November 3, 2017

RE: Zoning Challenge
249 East 62nd Street
Block 1417, Lot: 22
Job No: 122975995

Massing of proposed building color coded by use

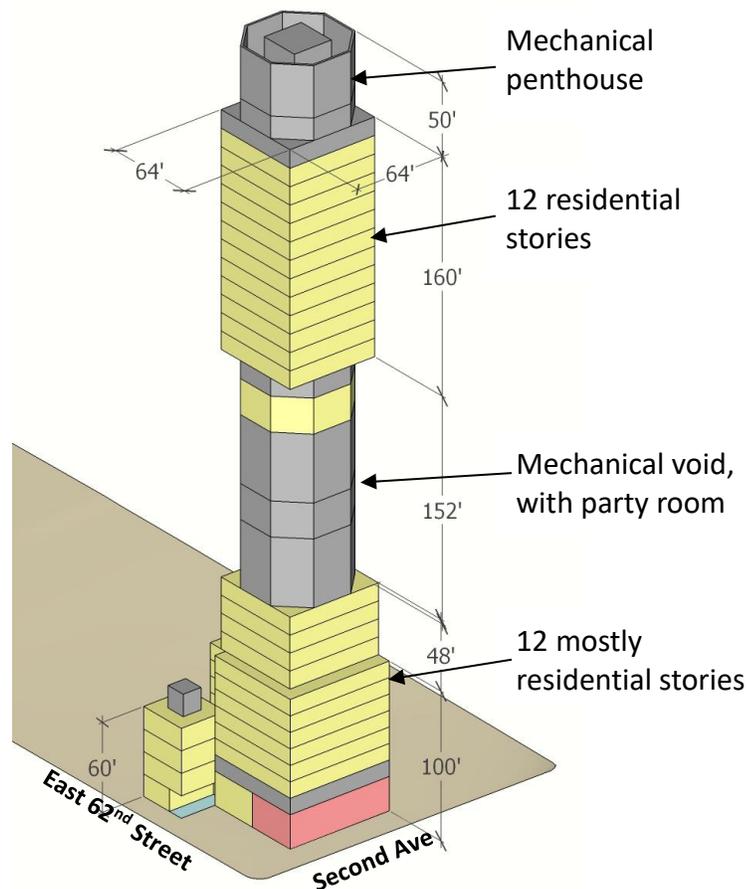
The proposed form is tower-on-base (23-651), but this tower-on-base is unlike most any other and includes a huge inter-building void of approximately 150 feet, which contains no residences. The top 12 residential floors sit on top of this void and start at approximately 300 feet.

My office modeled a massing of the building as proposed, shown below. Dimensions and locations of uses are approximate, as not all are shown on the ZD1. Yellow areas are residential floor area, gray areas are mechanical spaces and red areas are commercial.

Detail of plan from ZRD1 51136

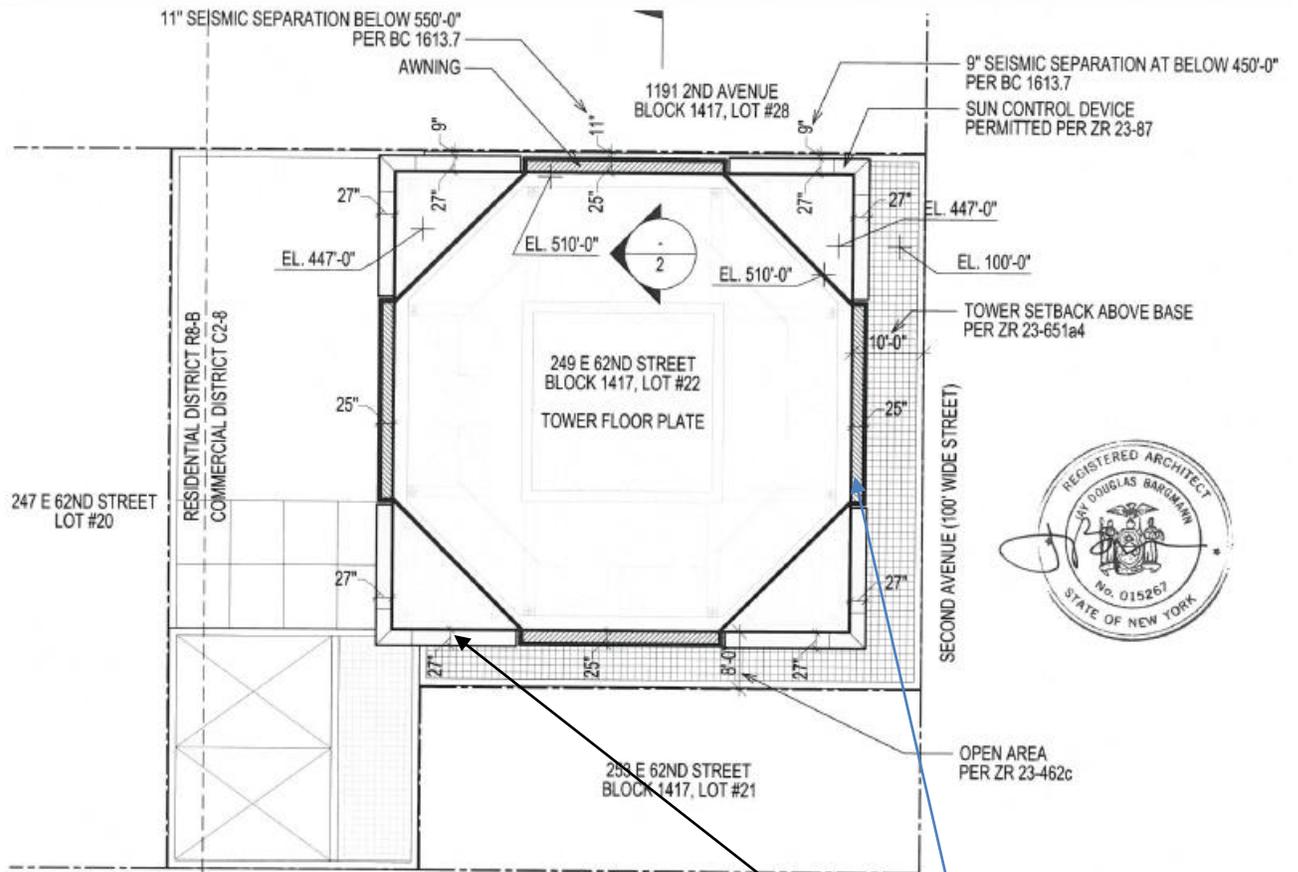
ZRD1 51136 of 9/5/2017 concerns the sun shading devices planned for the upper floors of the building. The following show a plan and perspective view taken from that ZRD1:

At issue is the northern lot line. Regarding side lots, ZR 23-462 (c) states:

"If any open area extending along a #side lot line# is provided at any level, it shall have a minimum width of eight feet"

Reproduction of perspective view of building with shading devices from ZRD1 51136

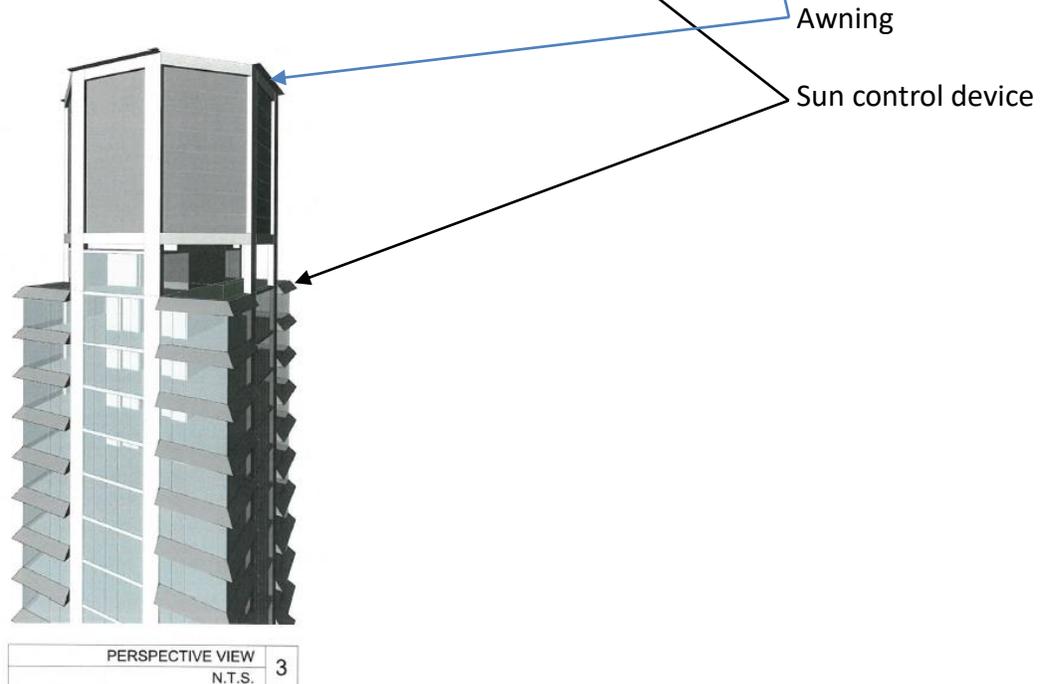
Indeed, ZRD1 51136 states that the solar projections are permitted obstructions in a side yard under 23-44. This is true, they are permitted obstructions in a side yard: a side yard that is too small to comply with 23-462 (c).

Second Avenue elevation with three foot side yard identified. The awning and sun control devices are permitted obstructions and so not shown.

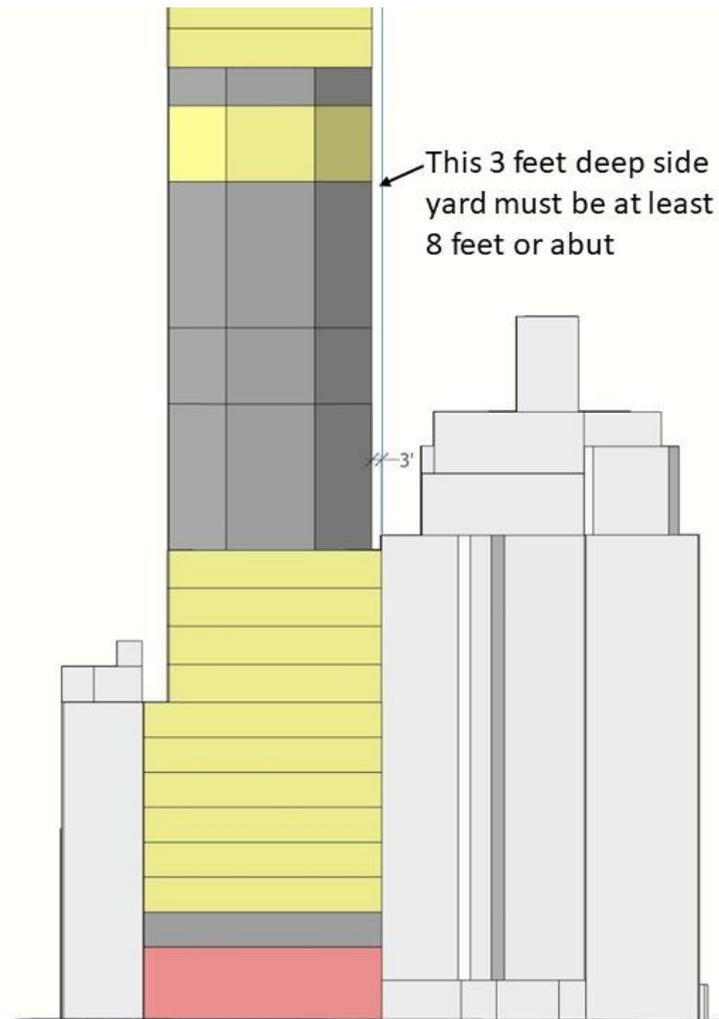
There is an open area of three feet between the building wall of the new building and the lot line. If this space were eight feet, it would comply. If this space were 11 inches (the required seismic separation distance), it would also comply since ZR12-10 states that abutting buildings do not include: "separations required for seismic load as set forth in the New York City Building Code." But a three foot separation, even when up to 11 inches of that is required seismic separation distance, is not allowed under 23-462 (c) and does not comply with the side yard requirement for this district.

Detail of the plan from the ZD1

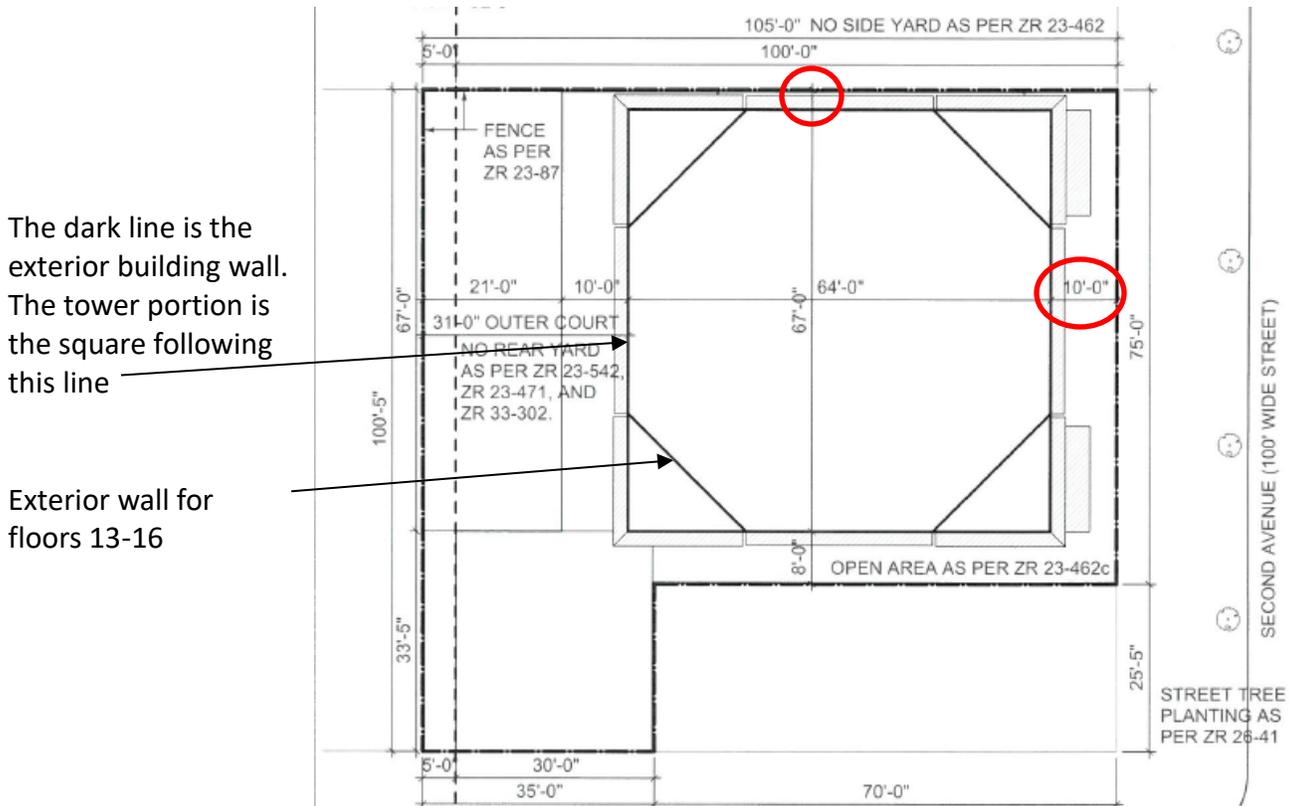
The northern side shows the “building” extending to the lot line (note the 67’ measure goes all the way to the northern lot line.) Effectively, the projections count as an exterior building wall for the purposes of the side yard. On the other three walls, the projections do not count as an exterior building wall. Had the other three walls used the standard described by ZRD1 51136, the tower would be 69 feet by 69 feet, or 4,761 SF. A tower of this size would be 54.3% of the zoning lot, which would mean that the tower is too large under 23-651, which limits towers on lots of this size to no more than 50% of the zoning lot.

Further, ZR 23-651 requires towers to be setback 10 feet from a wide streetline. It is only 10 feet from the exterior building wall, not from the sun-shading devices that function as the exterior building wall on the north side. The applicant is mixing and matching standards on the same building, selecting whichever standard benefits them most. The applicant’s intention to mix and match standards is not clear in the ZRD1; there is a difference in the representation of the exterior building wall when compared to the ZD1. In the ZRD1, the wall is shown to the edge of the awning on all sides. On the ZD1 it is only shown to the edge of the awning on the north side.

Approximate building massing annotated by use

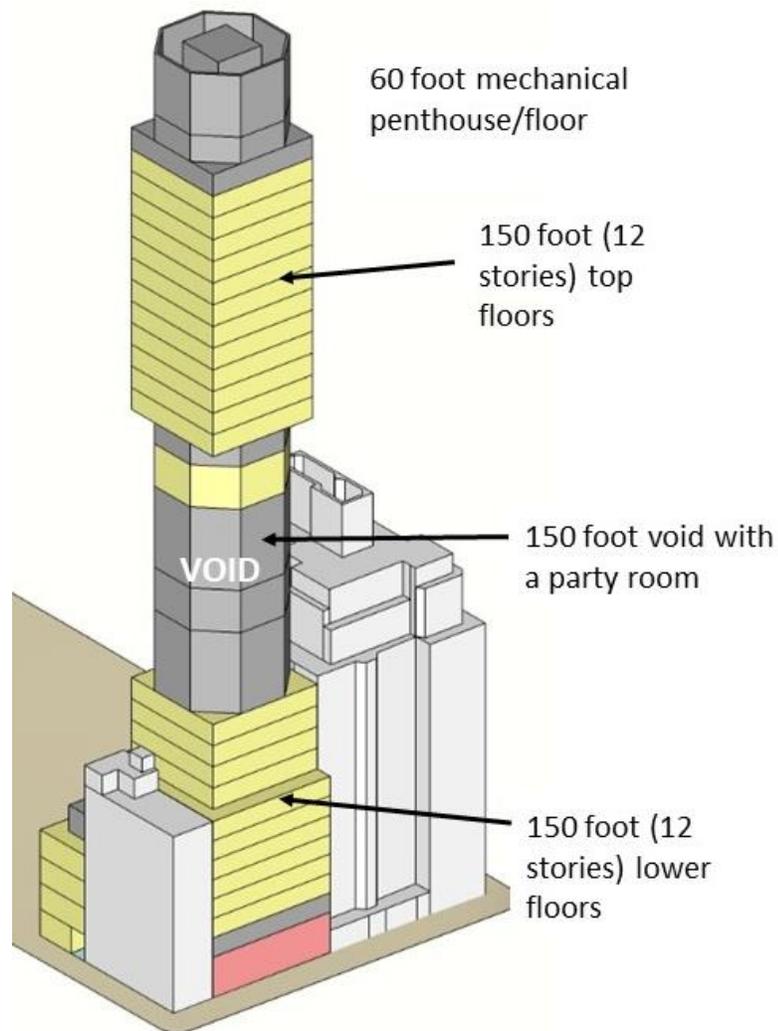
We see the mechanical portion of the proposed building in gray. At issue is the space that starts at approximately 148 feet and extends to 300 feet. This space is mostly empty, but also includes an amenity room. Excluding the cellar, the amount of the building's gross floor area devoted to mechanicals and other exempt spaces is 25%.¹ Many of these mechanical void floors have very large floor-to-floor heights so that the volume of this building devoted to mechanicals and voids is nearly 31% of the building's mass. This percentage goes up to 33% if we consider the area not open to the sky that is also inscribed by perimeter walls.

This is an exceptional amount of space devoted to accessory building mechanicals and other exempt spaces. Clearly, much of this space, its configuration and floor-to-floor height serves another purpose, which is to provide extra height to the building's upper floors, yet the DOB still found the area exempt from floor area
